TECHNICAL SERVICE BULLETIN

Bulletin Number: **V-06-01**
Model Years: **2006**

SUBJECT: INCORRECT TIRE LOADING INFORMATION ON VIN DECAL

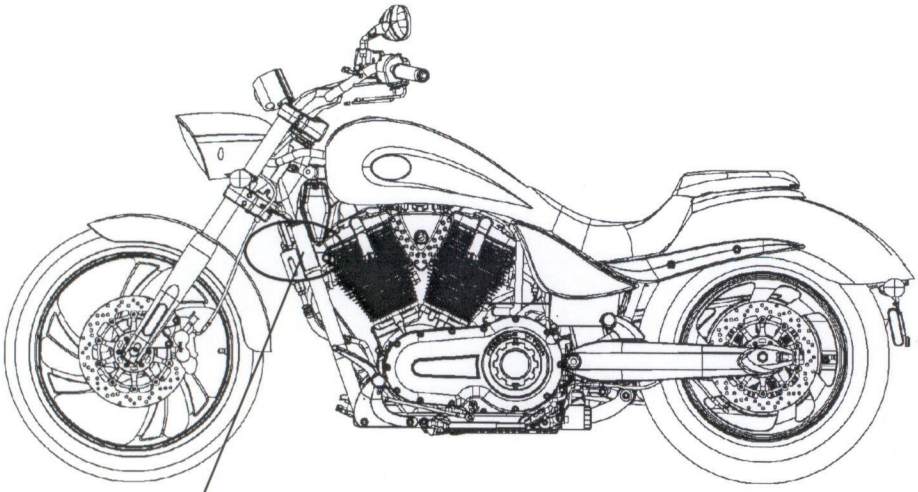
Apply decal over the GAWR portion of the VIN decal on the motorcycle.

1. Clean the decal on the motorcycle with warm soapy water to remove all oil, grease or dirt.
2. Rinse with clear water.
3. Dry decal and surrounding area thoroughly.
4. Carefully remove a new GAWR decal at right and apply it over the GAWR area of the decal on the motorcycle as shown. Be sure all previous GAWR information is covered, and press decal firmly in place.

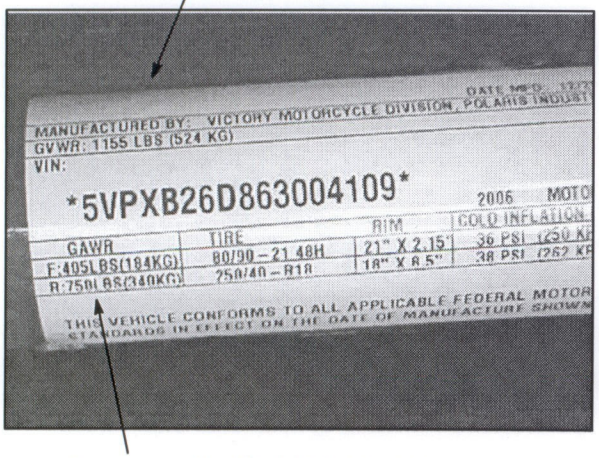
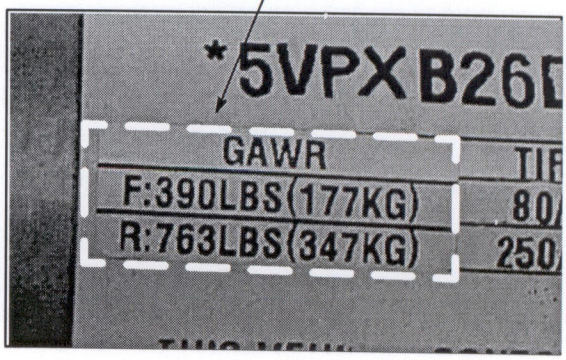
On the affected motorcycles, the Vehicle Identification Number (VIN) decal located on the left front downtube of the motorcycle frame incorrectly lists the GAWR (Gross Axle Weight Rating) for the front axle as 405 pounds. The correct GAWR for the front axle is 390 pounds. Reliance on the incorrect data may lead to overloading of the front tire which can result in a sudden loss of vehicle control and possibly a crash.

Incorrect: F: 405 LBS (184KG)
R: 750 LBS (340KG)

Correct: F: 390 LBS (177KG)
R: 763 LBS (347KG)
